#2017-18 McDonald's SUP Amendment Project Review for Planning and Zoning Commission

<u>Meeting Date:</u>	June 21, 2017
<u>Requests:</u>	A Special Use Permit Amendment to allow changes to the approved elevations, site plan and landscape plan.
<u>Location:</u>	551 Crystal Point Drive
<u>Acreage:</u>	Approximately 1.17 acres
<u>Zoning:</u>	B-2 (General Commercial)
<u>Surrounding Properties:</u>	North: B-2 PUD (General Commercial Planned Unit Development) South: B-2 (General Commercial) East: B-2 PUD (General Commercial Planned Unit Development) West: B-2 (General Commercial)
<u>Staff Contact:</u>	Kathryn Cowlin (815.356.3615)

Site Plan:

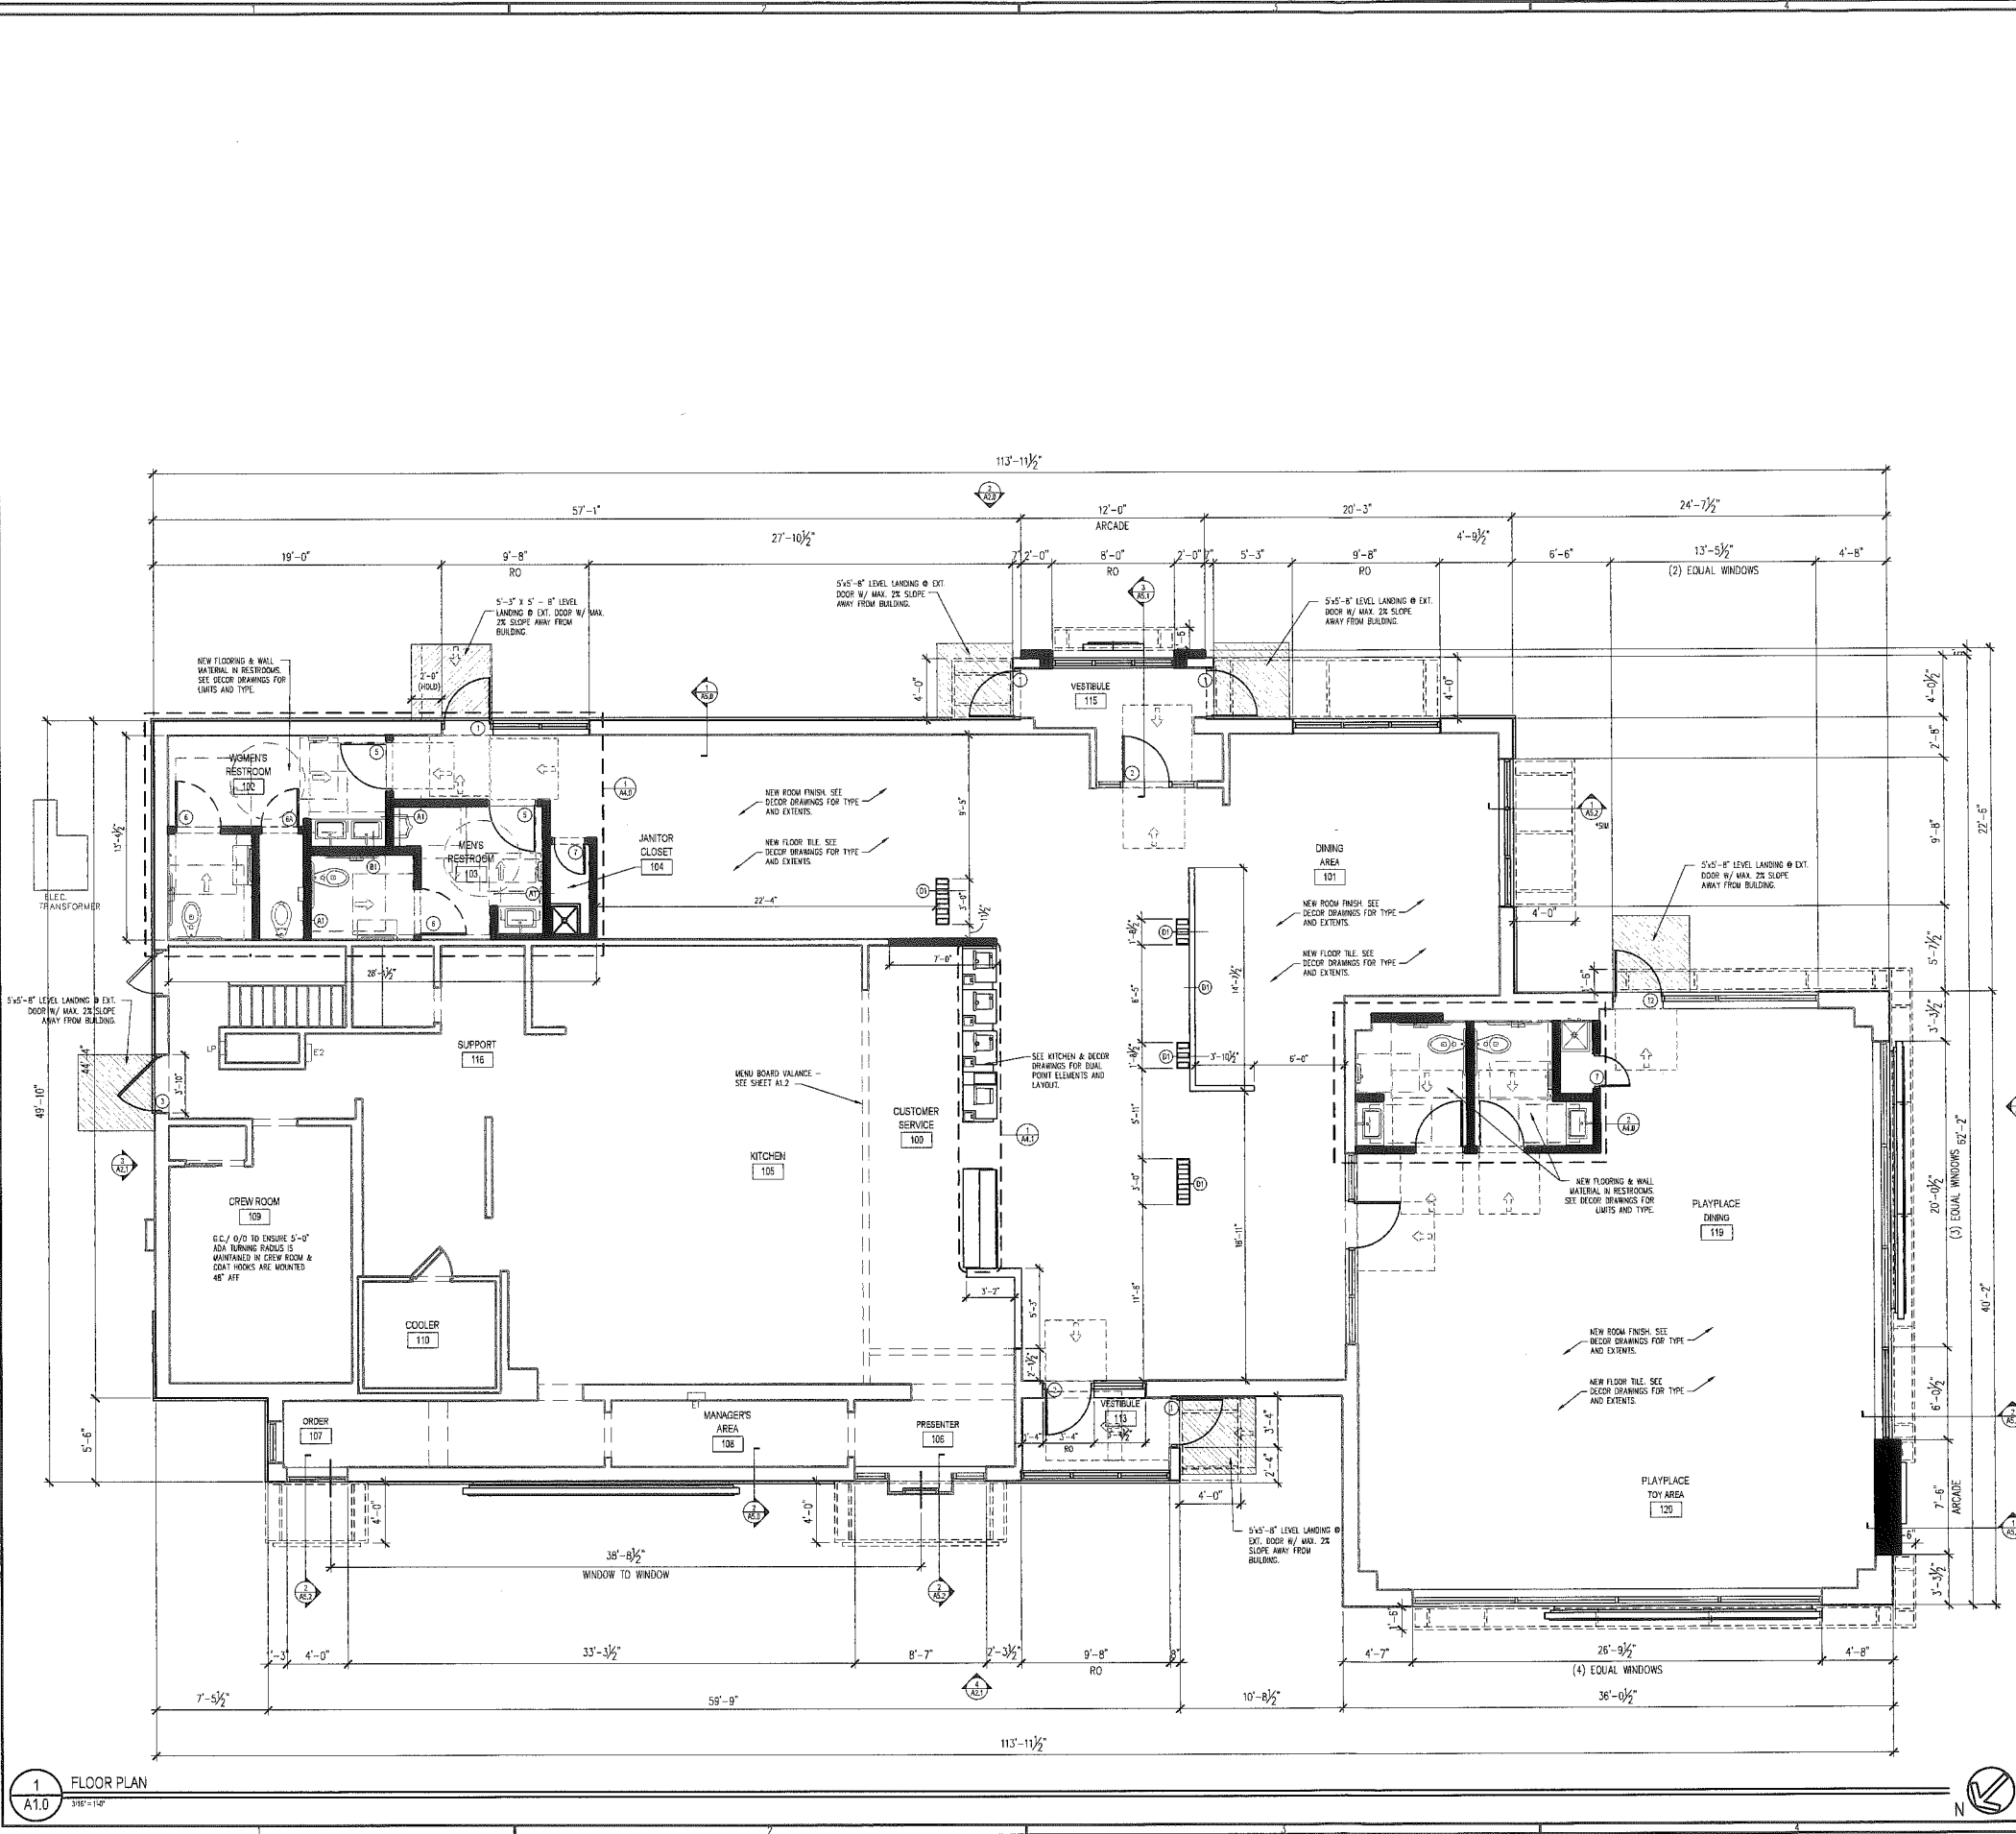
- A second drive-through lane is proposed to reduce existing stacking issues.
- The on-site circulation pattern will be altered.
 - On the north side, the existing landscape island and a sidewalk will be extended towards the building, creating a barrier between the drive-through drive aisle and the parking stalls.
 - Striping will be added across the drive-through drive aisle from the new sidewalk to the existing building entrance.

- Due to the changes in site circulation, the north access drive will be changed to an exit only.
- Parking spaces will be removed along the south side of the building and a more defined drive aisle will be striped for the drive-through stacking spaces.
- The new circulation pattern and additional drive-through lane reduces the existing number of parking spaces from 63 to 54 spaces. Fifty-five (55) parking spaces are required for this property per the UDO. Previously, the property was granted a parking variation of 8-spaces; therefore, the property would comply with the parking requirement.

Proposed Façade:

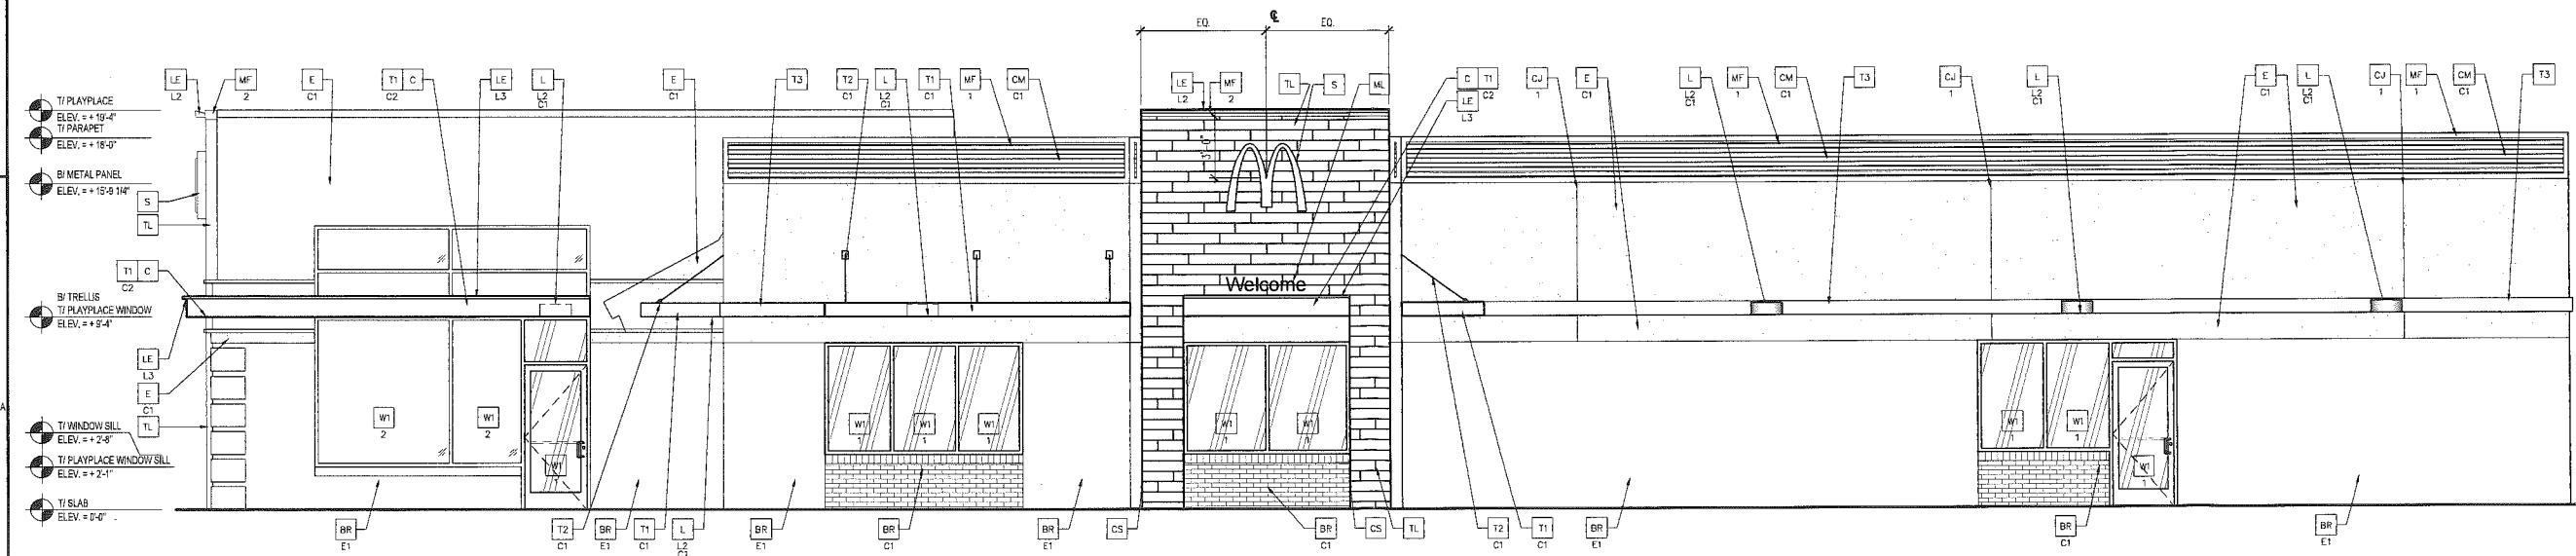
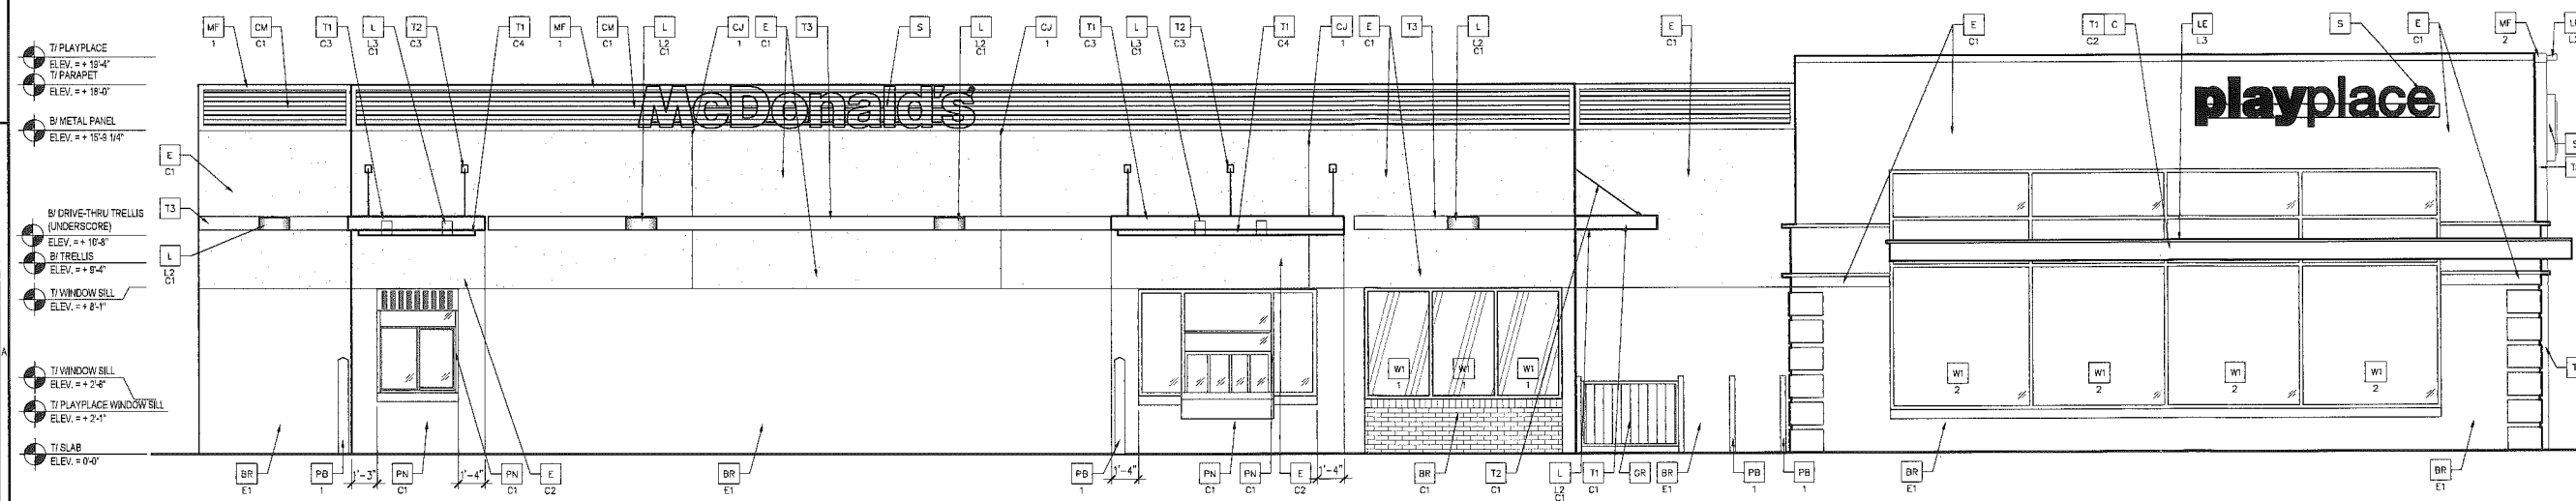
- The proposed changes to the exterior elevations meet the Unified Development (UDO) design standards for a renovation.
- The proposed elevations are a modern architectural design.
- The existing building is constructed of brick and the proposed changes include painting and adding brick under the new windows.
- The proposed façade is accented with tile that looks like wood and the color scheme is gray and white. A colored rendering of a different location is attached to illustrate how the McDonald's will look like with the Iron Mountain and Chelsea Gray color scheme.

- The mansard roof would be removed and replaced with a flat roof. Metal awnings and corrugated metal will be utilized to accent the façade in gray tones.

Landscape Plan:

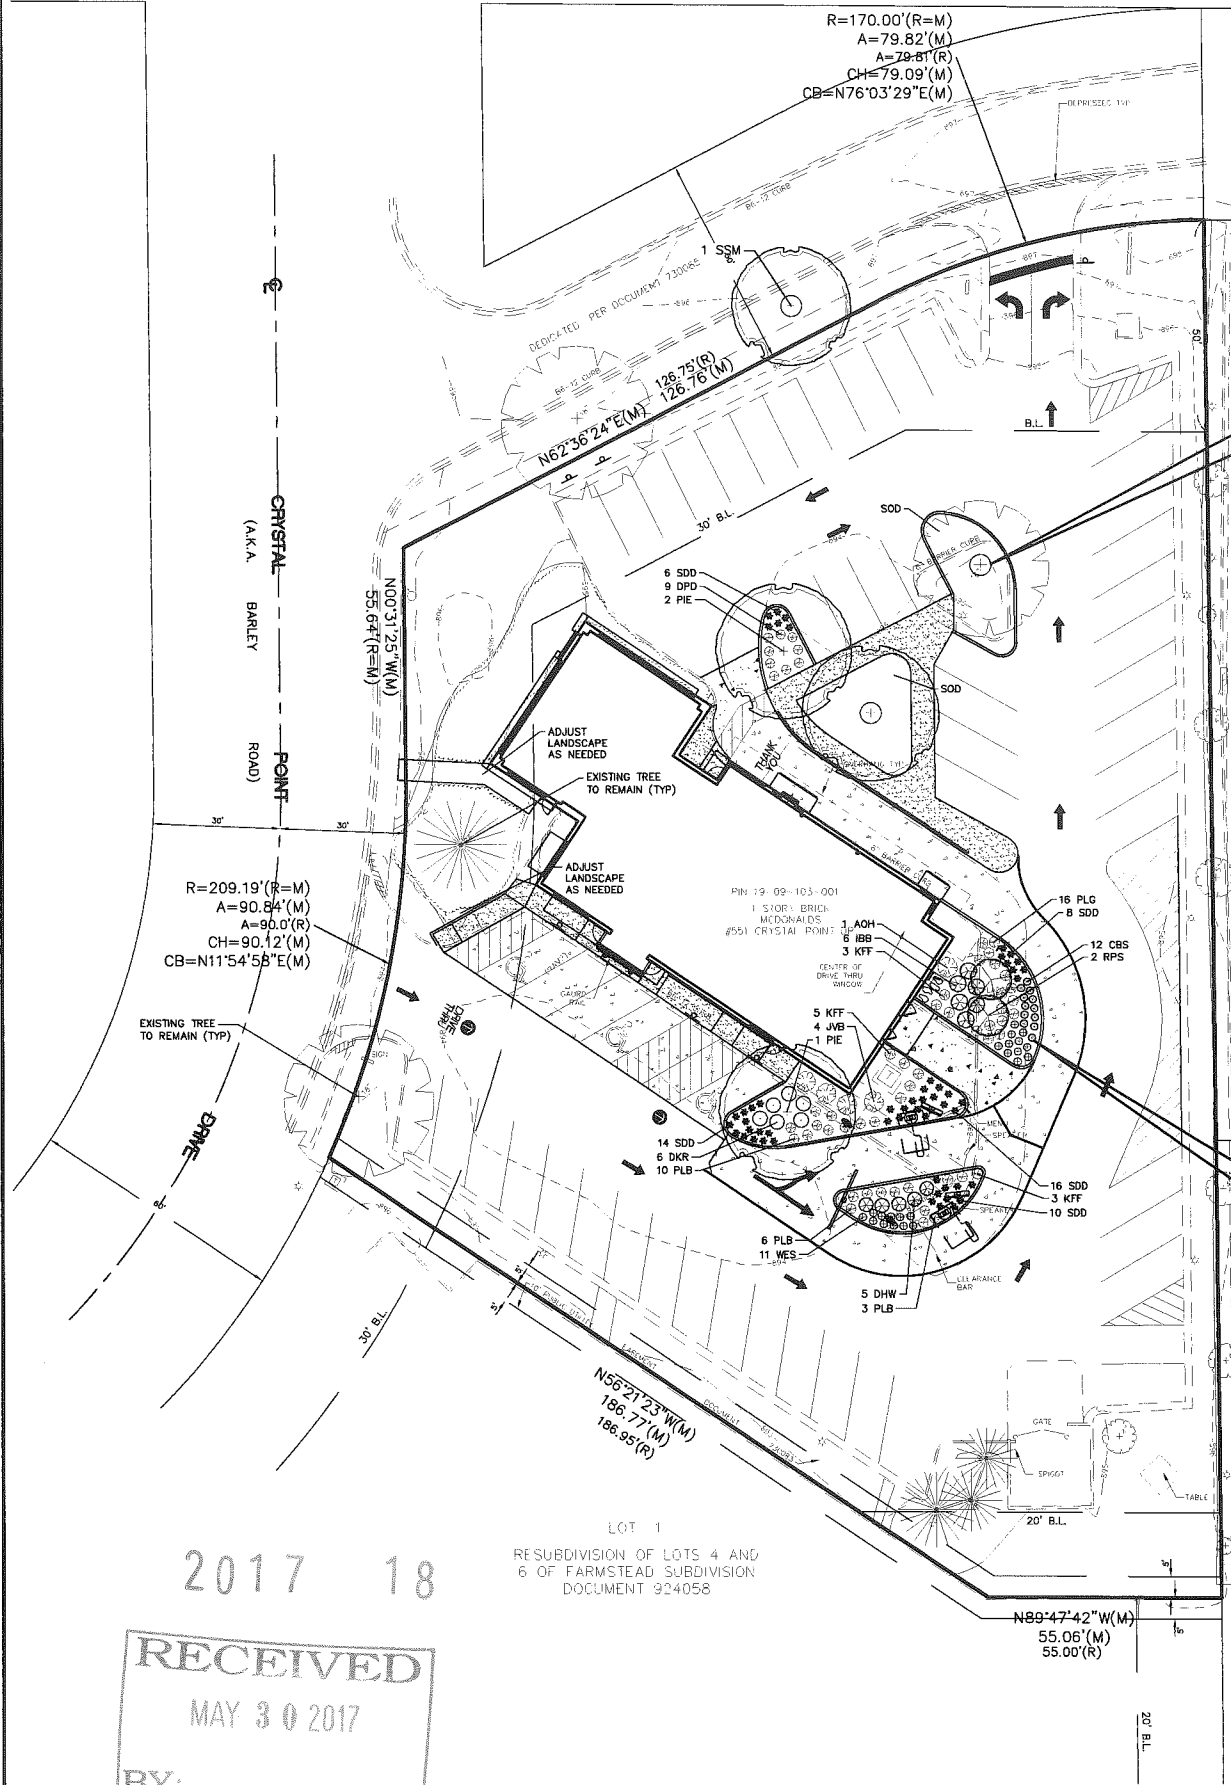
- Additional landscaping will be added to the rear of the building, which will screen the building mechanicals.
- Three trees will be added to the property and an additional parkway tree will be planted along the access road.
